COMMUNITY DEVELOPMENT DEPARTMENT REPORT

SUBJECT: FP-2025-0030
Adero Park No. 2 FP

LOCATION: 5435 N. Ten Mile Road, located in the
NE ¼ of the SE ¼ of Section 27, T4N,
R1W, Parcel No. S0427417210

E. Final Plat (date: Click here to enter a date.)

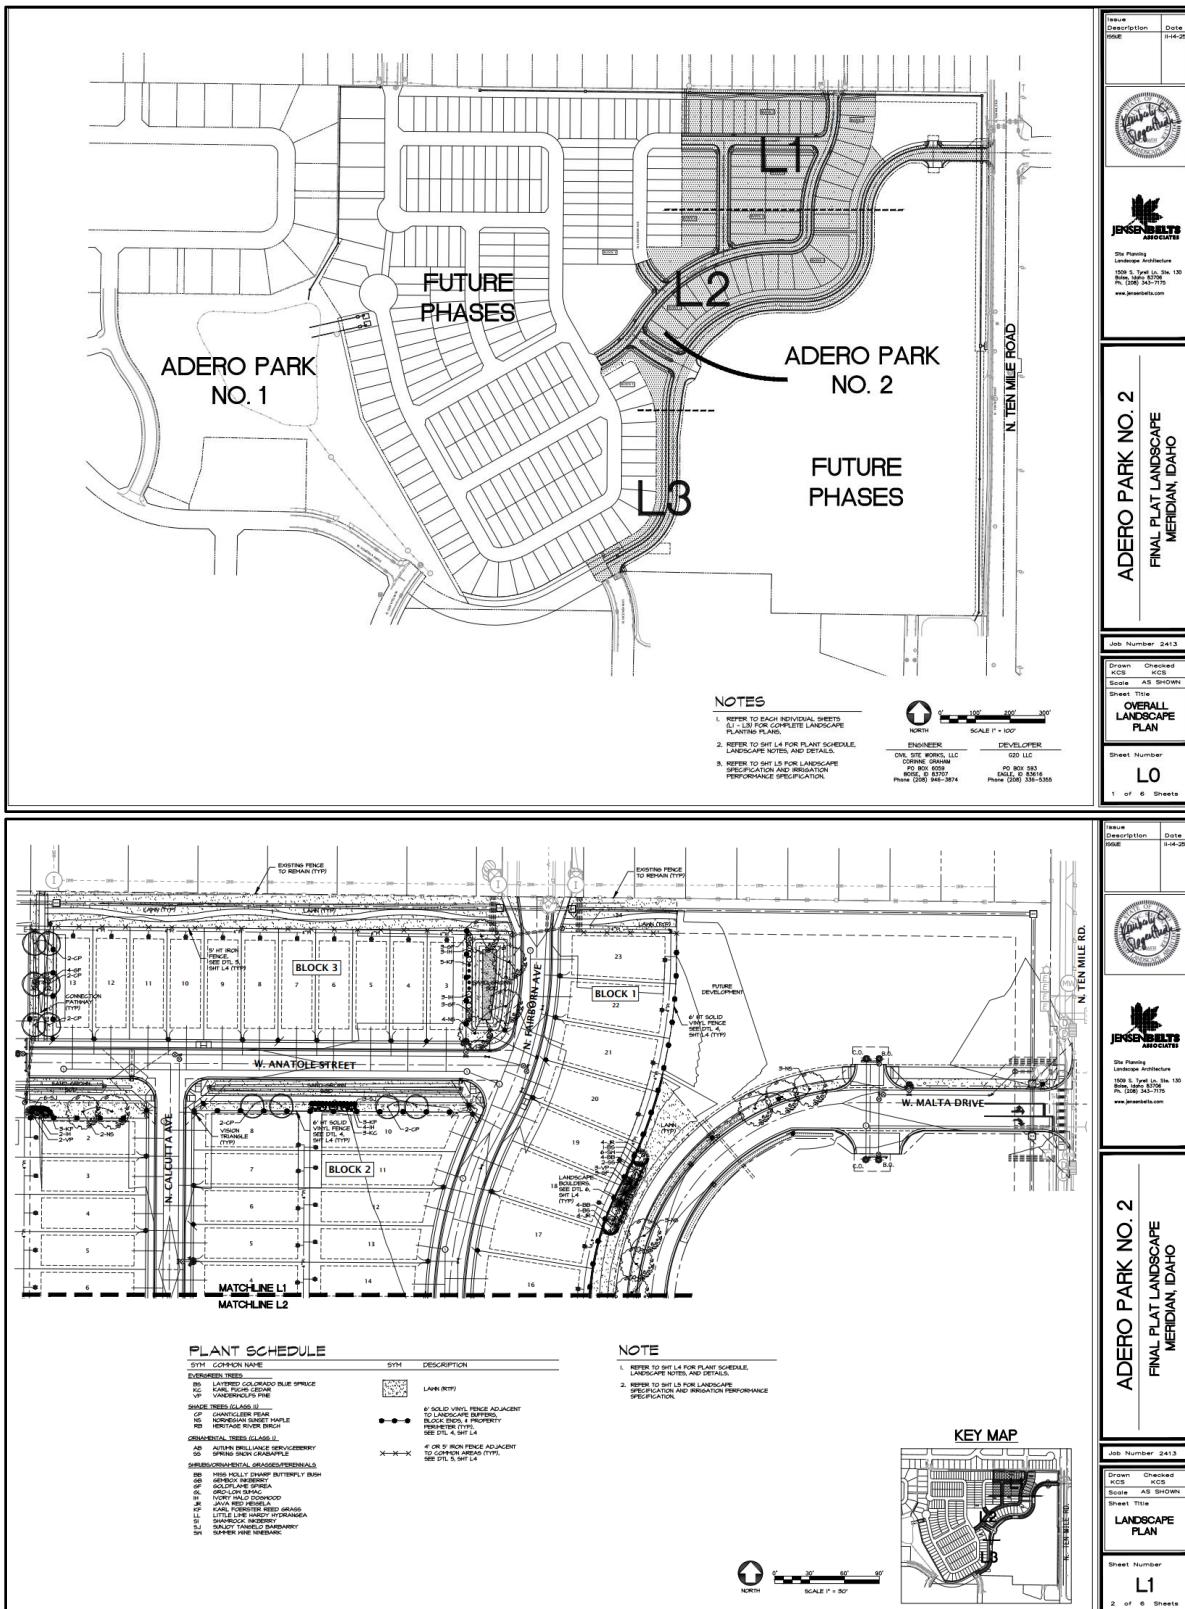
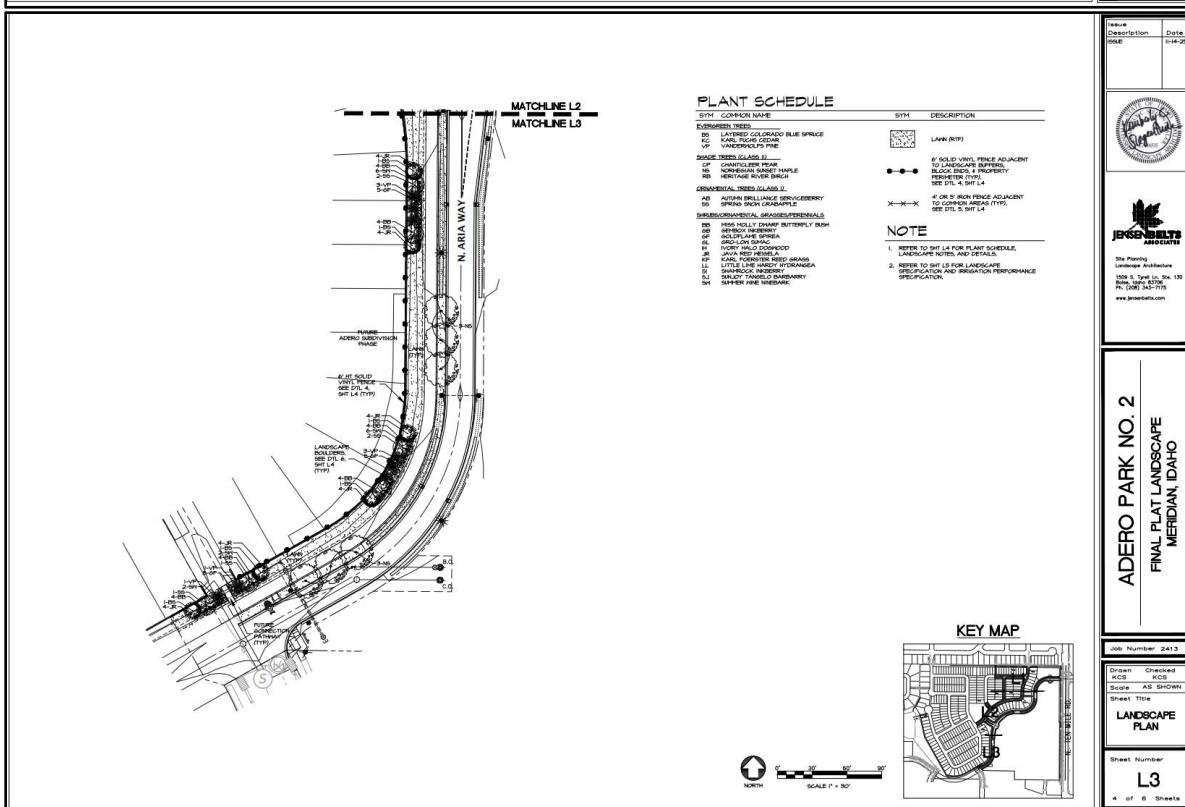
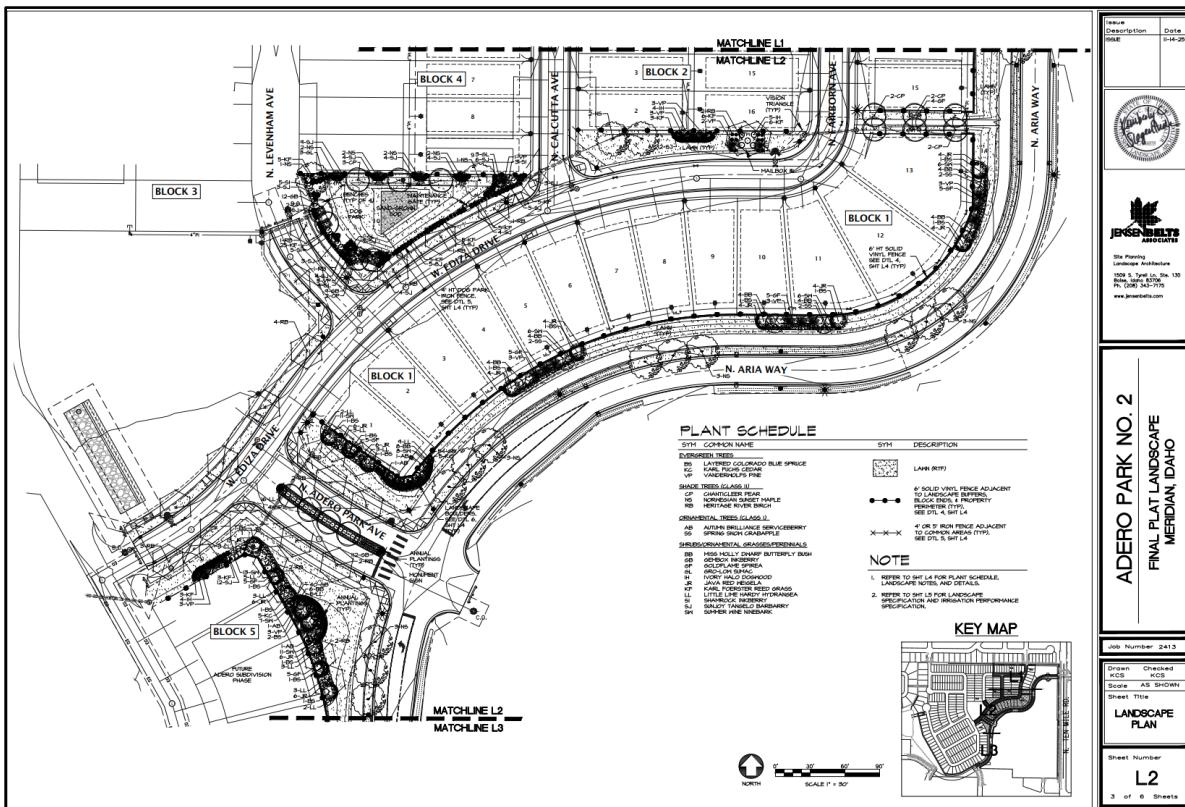
2. The final plat shown in Section V.B, prepared by Sawtooth Land Surveying, LLC, stamped on 11/7/2025 by Jeff Beagley, shall be revised prior to signature on the final plat by the City Engineer, as follows:

- a. Note #6: Include the instrument number for the ACHD license agreement.
 - b. Note #9: Include the instrument number for the Development Agreement.

- c. Note #10: Include the instrument number for the CC&Rs.
 - d. Note #13: Include the instrument numbers for the ACHD sidewalk easements.
 - e. Note #14: Include the instrument number for the City of Meridian sanitary sewer easement.

- f. Missed Note #15.
 - g. Note #16: Include the instrument numbers for the McMullen and Hudson lateral irrigation agreements.
 - h. Note #17: Include the instrument number for the City of Meridian water main easement.

- i. Note #18: Include the instrument number for the roadway easement.
 - j. Note #19: In the instrument number for the City of Meridian sewer and water easement. Only show the portion of the easement that is associated with the proposed plat.

- k. Revise the irrigation easement for the McMullen and Hudson lateral to show only the portion associated with the current plat.
4. W. Gondola/W. Malta Drive (N. Aria Way) shall be constructed to N. Vicenza Way, excluding only the ten (10) foot multi-use pathway and landscaping on the east side of the new collector roadway in the first phase. The remainder of the roadway to N. San Vito Way shall be completely constructed as a complete street including sidewalk and landscaping on both sides, prior to the issuance of a certificate of occupancy for the second phase.
